ADDENDUM NO. 1
to
CONTRACT DOCUMENTS

for
ADDITIONS AND RENOVATIONS
to the
PRINCETON MIDDLE SCHOOL
located at 217 Walnut Lane, Princeton, NJ 08540

Issued: January 15, 2026

FVHD PROJECT NO. 5516B

Drawing Number
A306

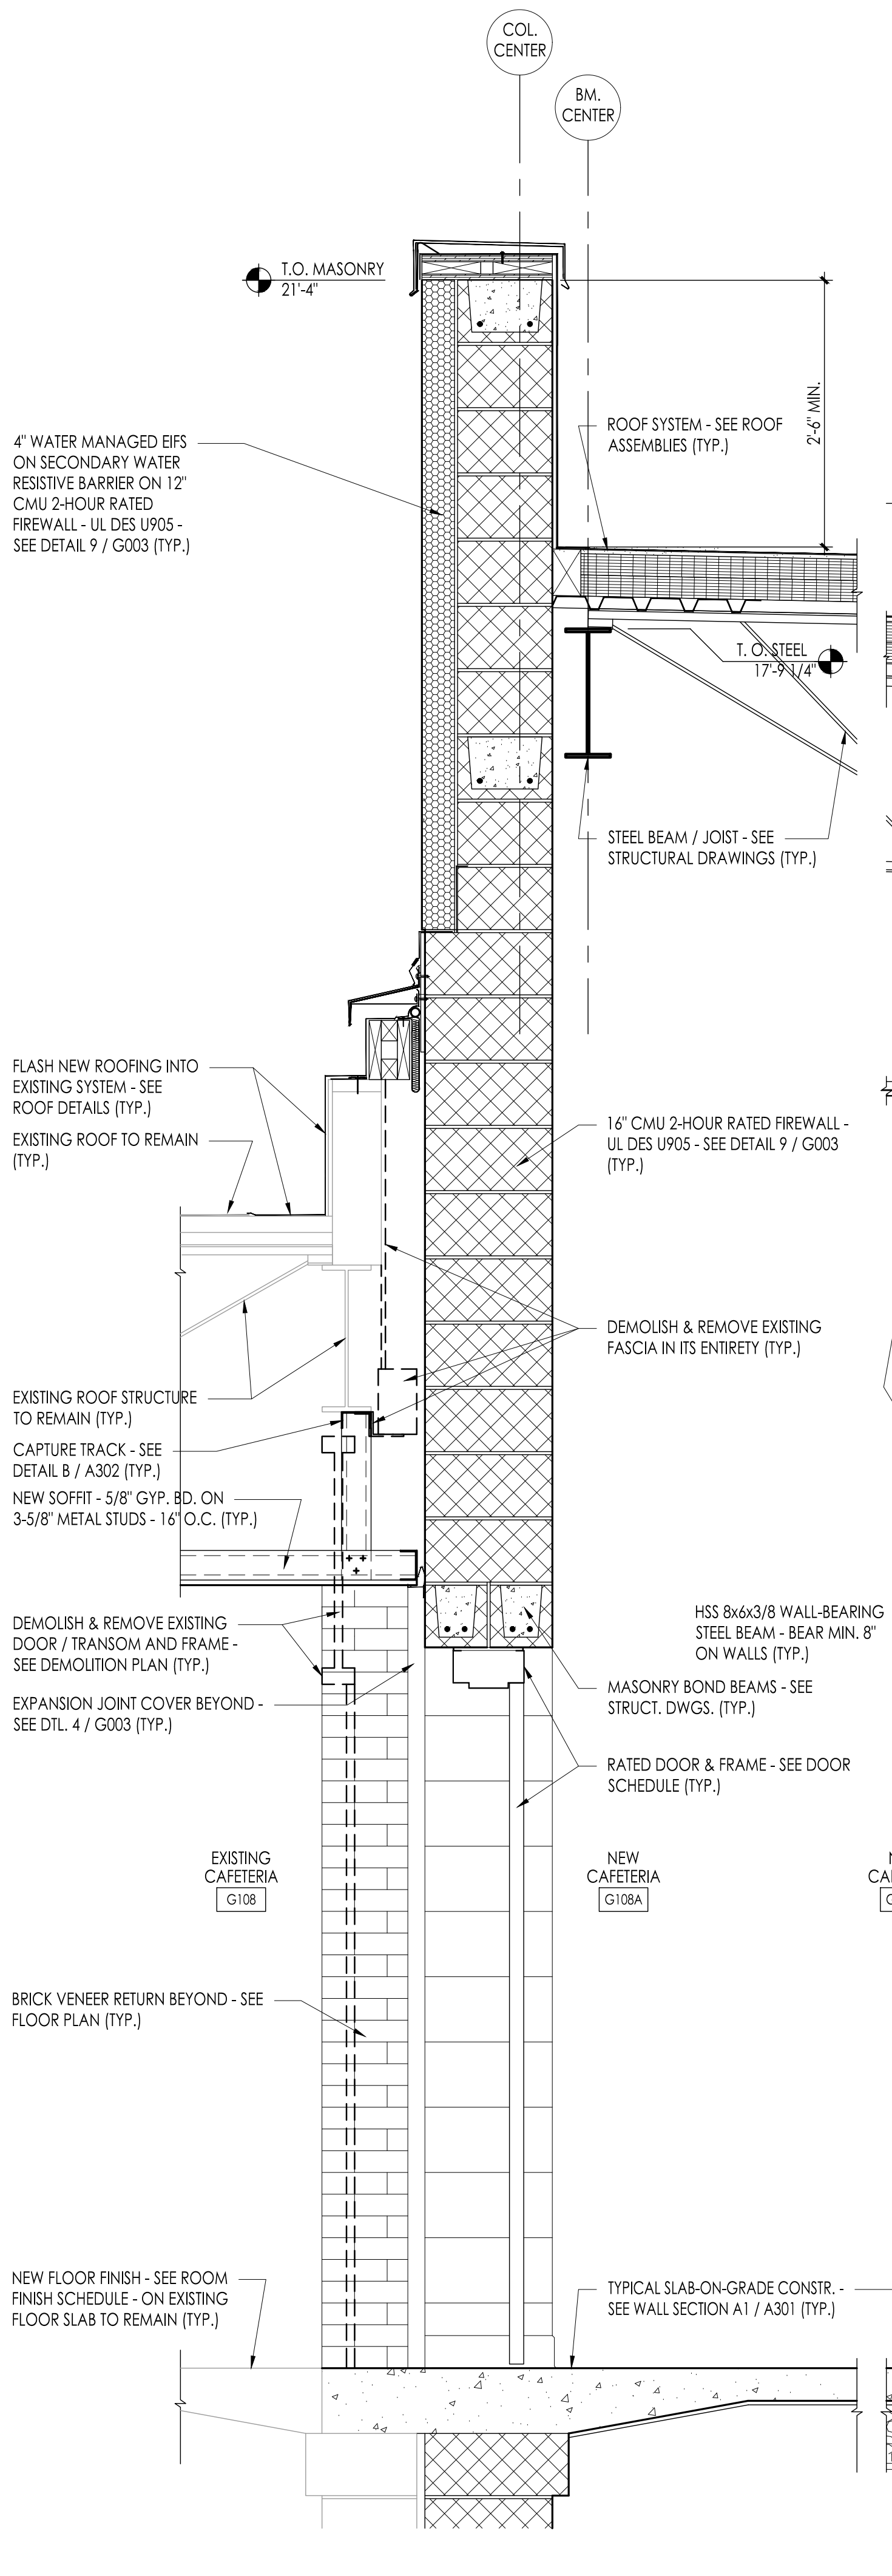
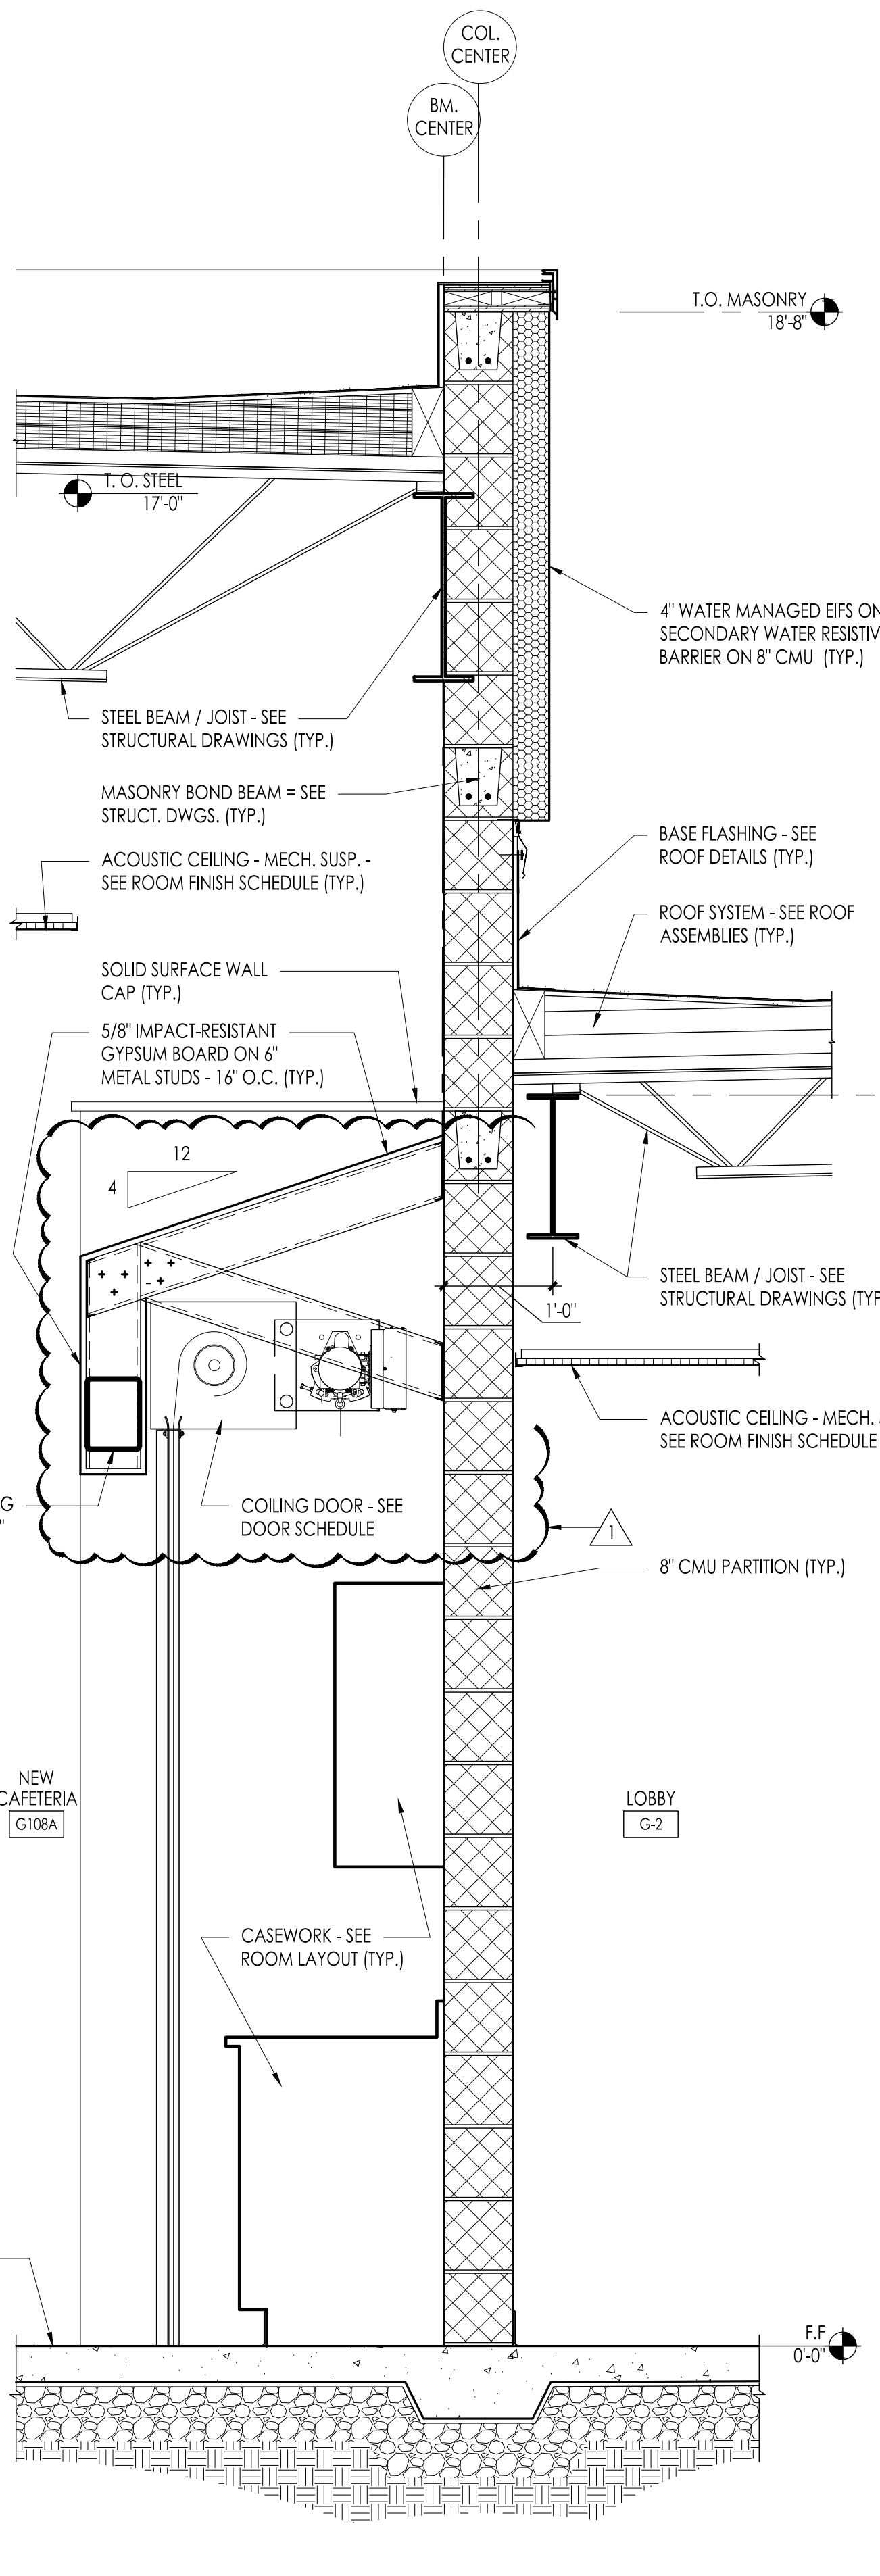
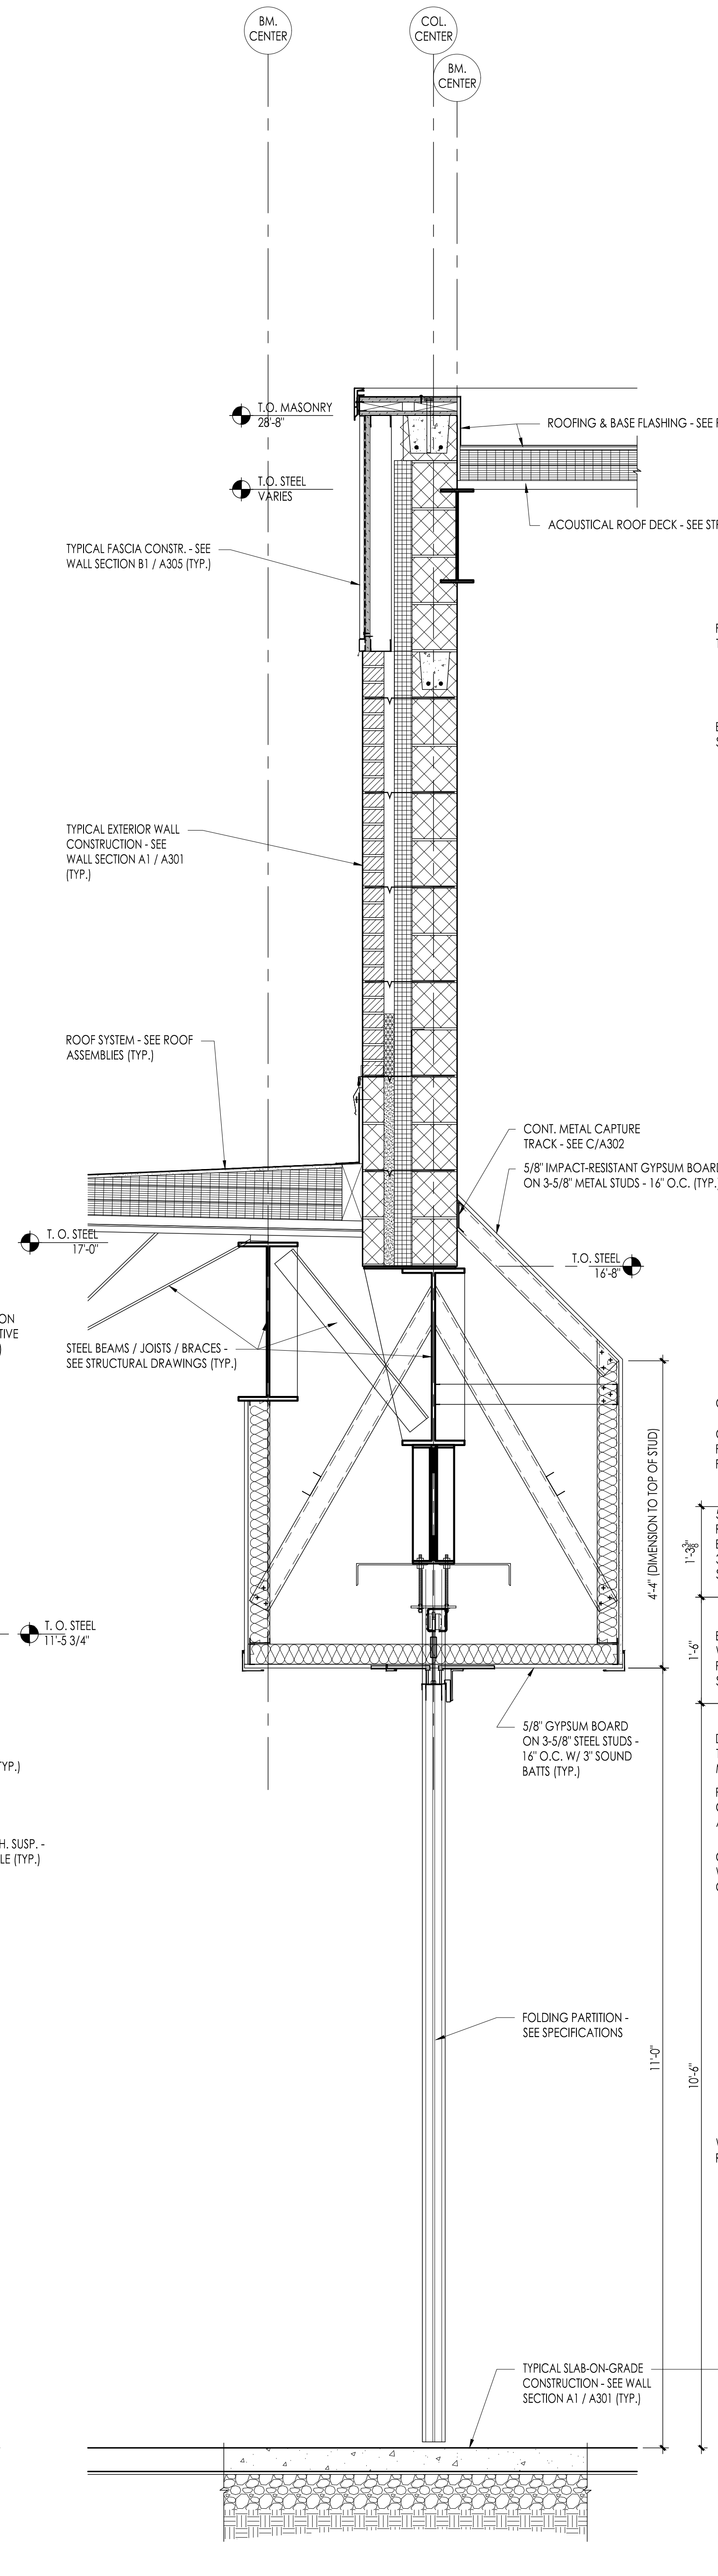
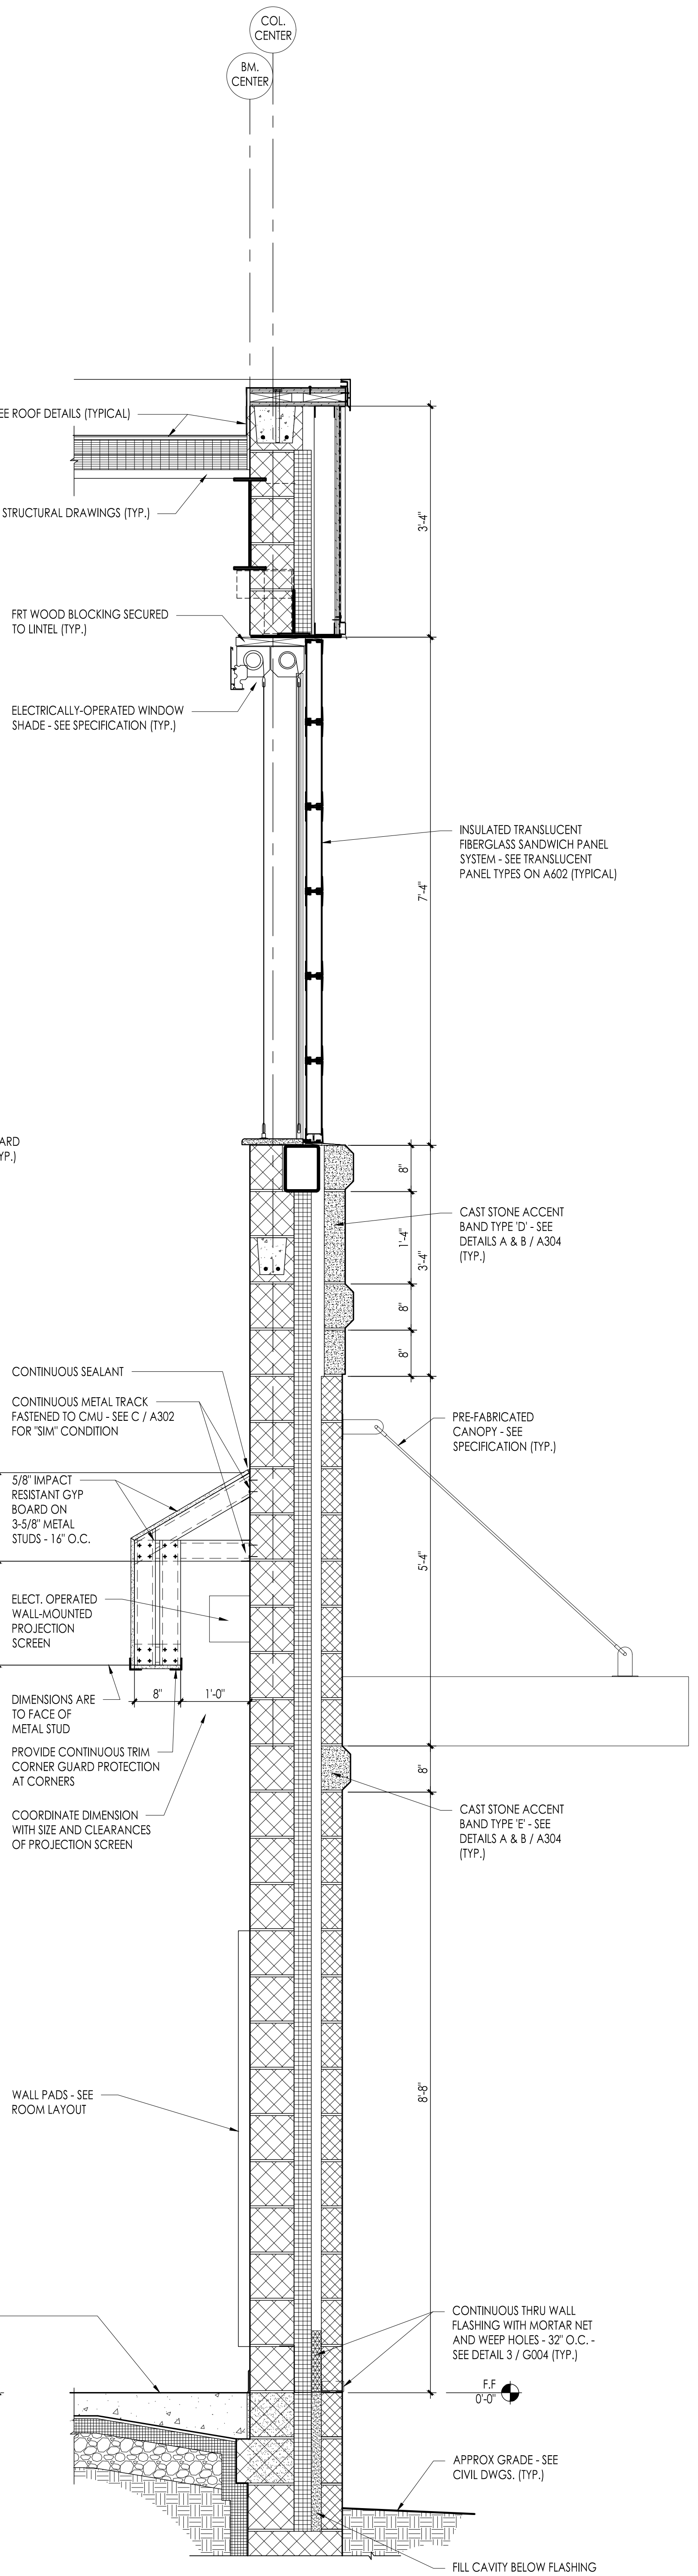
10. Question: Please confirm location of Overhead Doors, Specifications included, not on plans.

Response: Location and details are added to the drawings. See revised A105, A306, A601 and A602, attached to this Addendum.
